From: [REDACTED]
To: [REDACTED]
Subject: FOI info from Laptop for St Patricks Circle, Saul
Date: 30 June 2026 13:32:34
Attachments: [image001.jpg](#)
[image002.jpg](#)
[image003.png](#)

NIHE St Patrick's Circle, Downpatrick

Modelling Proforma – St Patricks Circle, Saul

NIHE Alternative discharge point St Patrick's Circle, Downpatrick

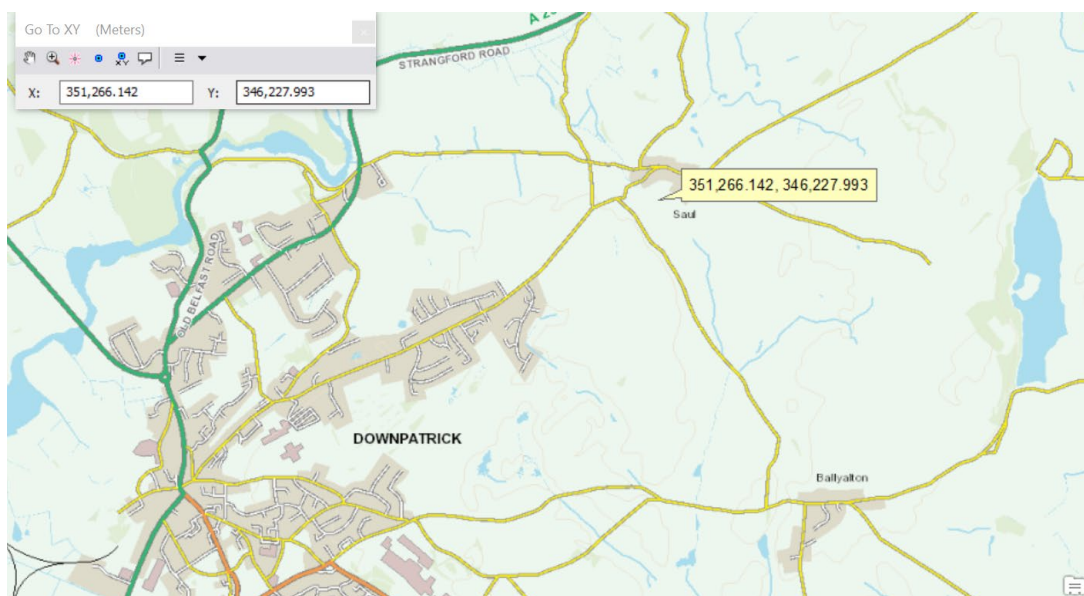
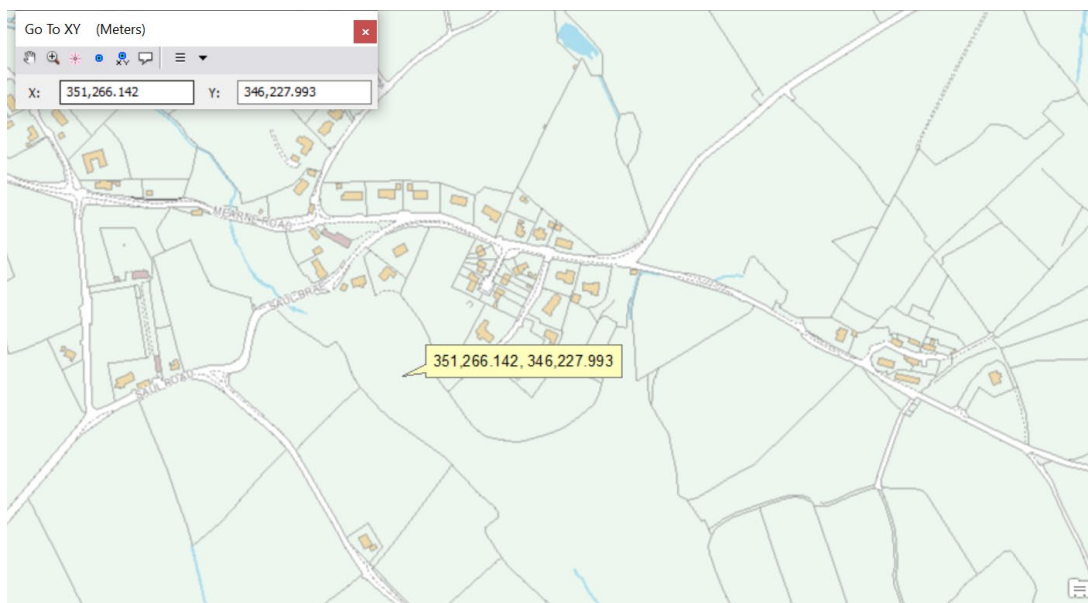
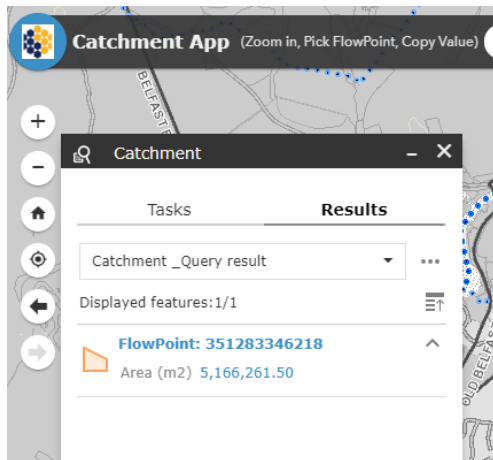
Although no waterway is present on Arcmap, NIEA's Catchment app shows waterway with catchment of 5.166KM

| 1. | Proposed Waterway for Discharge – Location Map including Eastings & Northings |

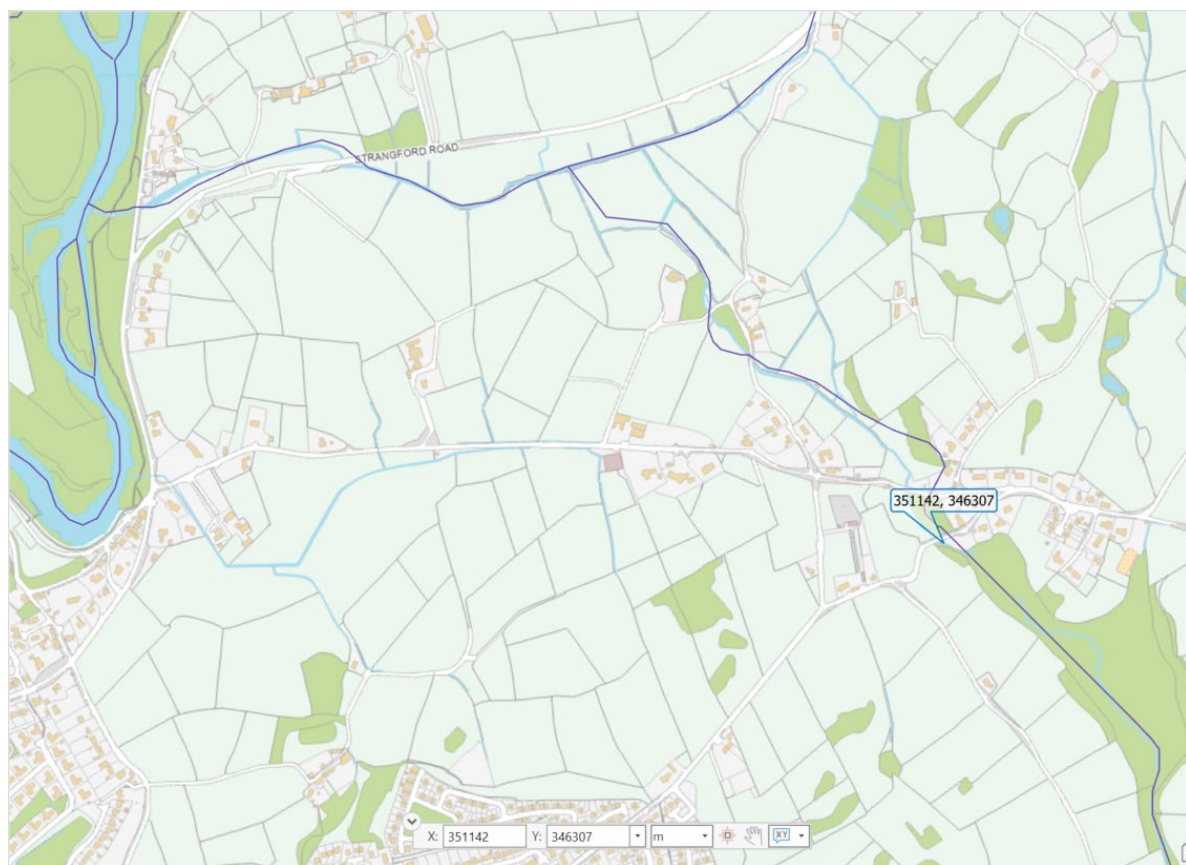
BOD – Moderate 5.64mg/l

Mid-Good is 3.5mg/l – to be used for modelling

Ammonia – High 0.151

High to Good boundary is 0.30mg/l

5.5	Conclusion and Decision
Permissible discharge quality limit: BOD: 14.96 mg/l : As waterway is in Moderate status the Modelling has been completed to achieve Mid Good status. Ammonia: 3.24 mg/l : As the waterway is in high status 10% deterioration has been permitted but no deterioration in class has been permitted. Therefore BOD limit of 10mg/l & ammonia limit of 10mg/l acceptable standard. Standards to be include in consent conditions: BOD 10mg/l, SS 15mg/l & Ammonia 3mg/l.	
5.6	Approval
Completed by: _____ Date: _____ 31/07/2025 _____ Approved by (Signature): _____ Date: _____

St Patrick's Circle Saul

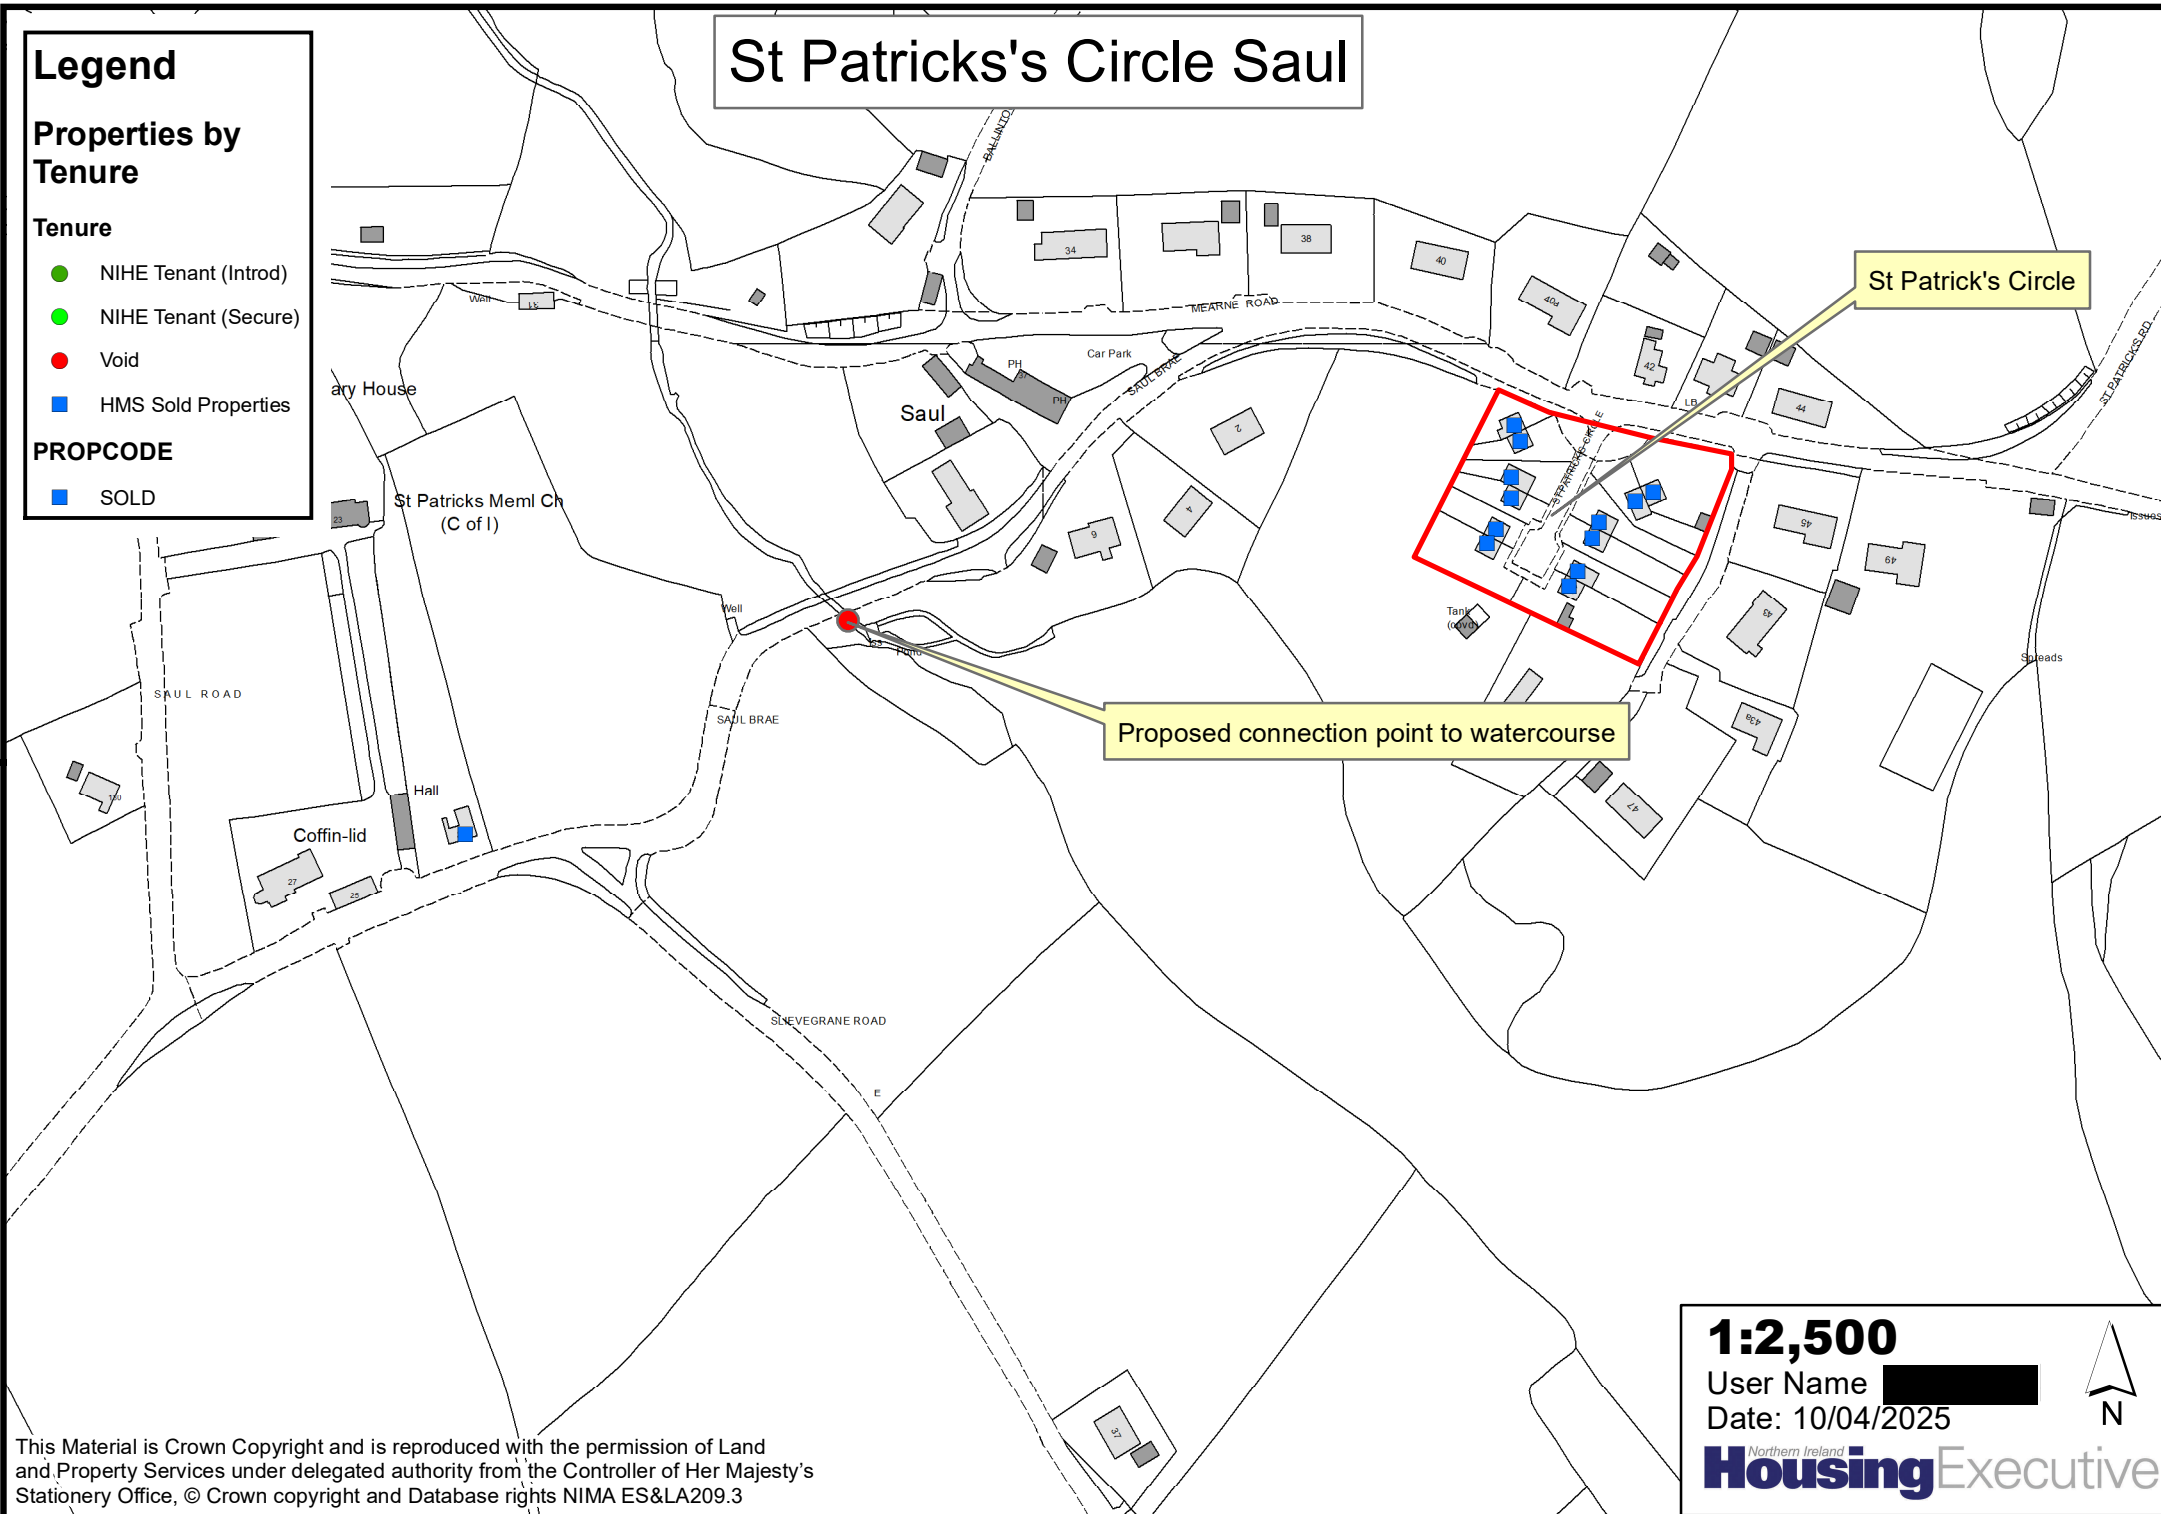
Given these extremely high costs we may consider the option for a non adopted solution which would include a new treatment works and discharge to watercourse at point shown on attached drawing.

Is it possible for you to organise a low flow measurement to see if such a connection is possible.

Thanks for getting back to me and I can confirm that based on flow data previously provided for your proposed discharge point, as you marked on the attached map, NIEA can consider this proposal, although I can't give you an idea of consent standards (BOD, SS and Ammonia) as yet.

I would state that NIEA's preferred option is always an NI Water adoptable system but as the site has been discharging for many years we may be able to consider this proposal without adoption. However, before you do any further investigation into this potential solution, I would ask that you confirm who will be the owner and therefore be responsible for the continued maintenance of this system. I ask this because without NI Water adoption, NIEA would have concerns with regards to security for future homeowners and ensuring long-term protection of the environment.

St. Patrick's Circle Saul

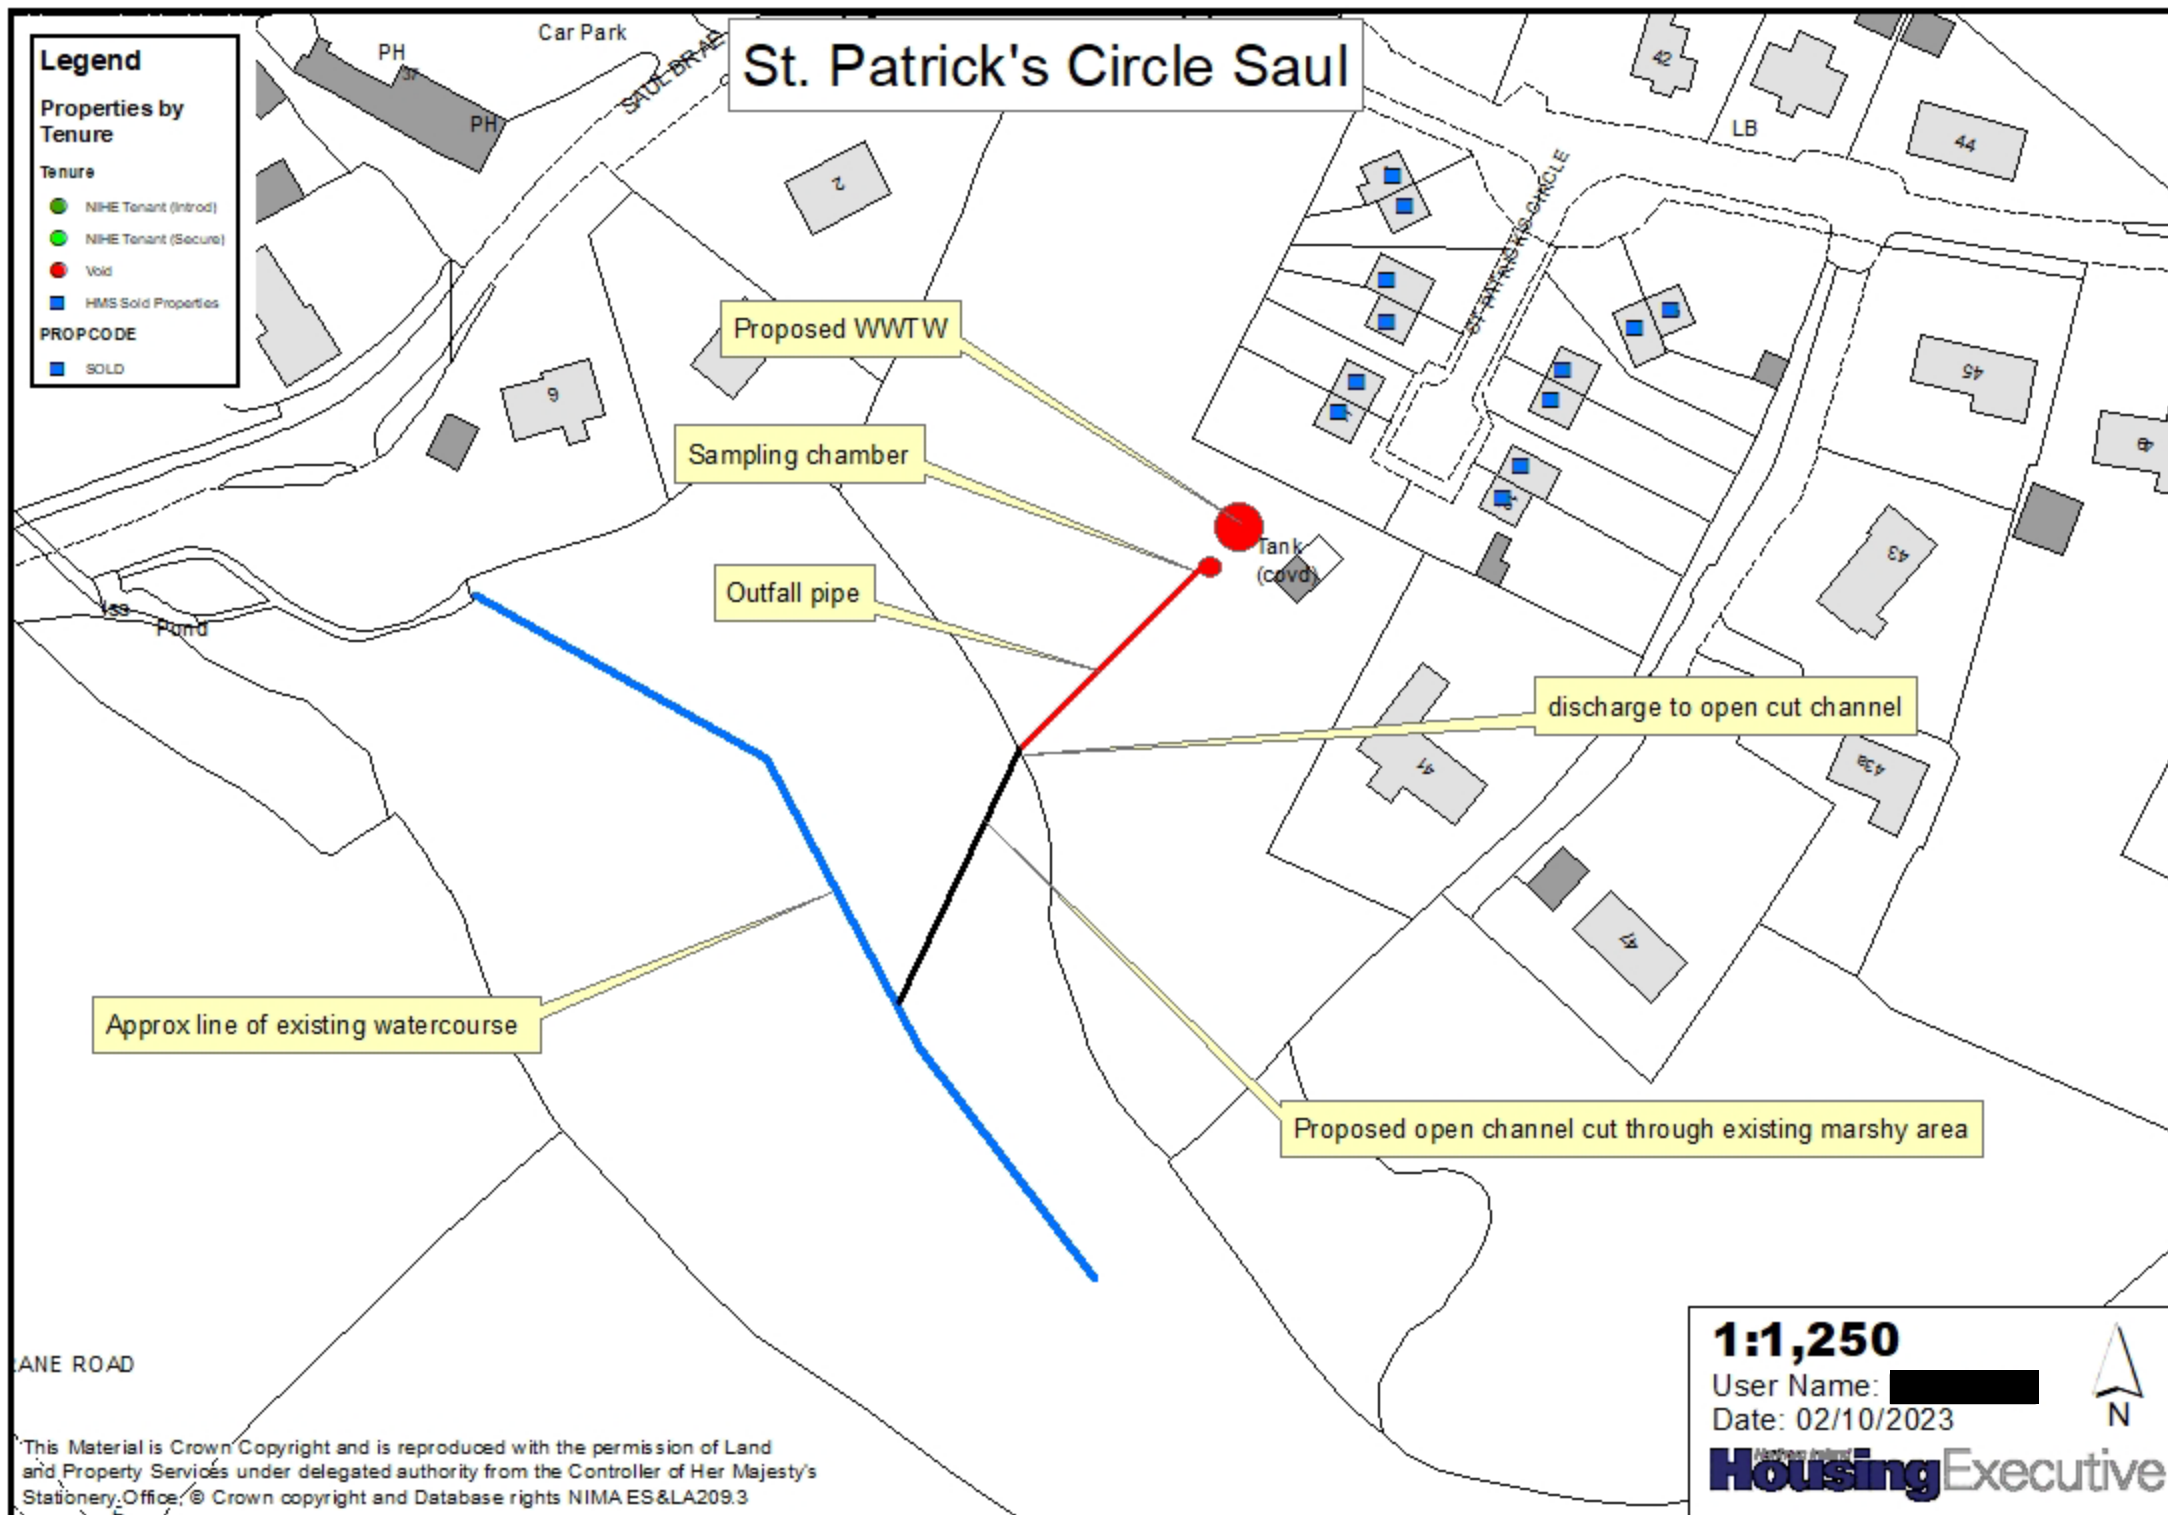
Is the attached approach a possibility, cutting an open channel through the marshy area.

I note on the map you have stated 'open channel cut through marshy area' would this be left open as NIEA would consider the channel a open sewer and probably not accept it. You would need to lay a pipe to the waterway within this channel and infill the ground.

However, NIEA could not make a final decision on this plan without further info: A proposed discharge point, volume of discharge (is it for all 12 properties? : ie 12 properties x 4 persons per property x 150L/person/day = 7,200L/day) and spec of effluent treatment works proposed.

If your director wishes for me to explore this solution I will submit a hydrology request to the team and get flow data – this will tell me max discharge volume NIEA would consent and the standards that would be set on your consent – let me know if you wish me to progress the checks..... Please note no final decision can be made without an actual consent to discharge application being submitted but the flow data will give me a good idea of the conditions.
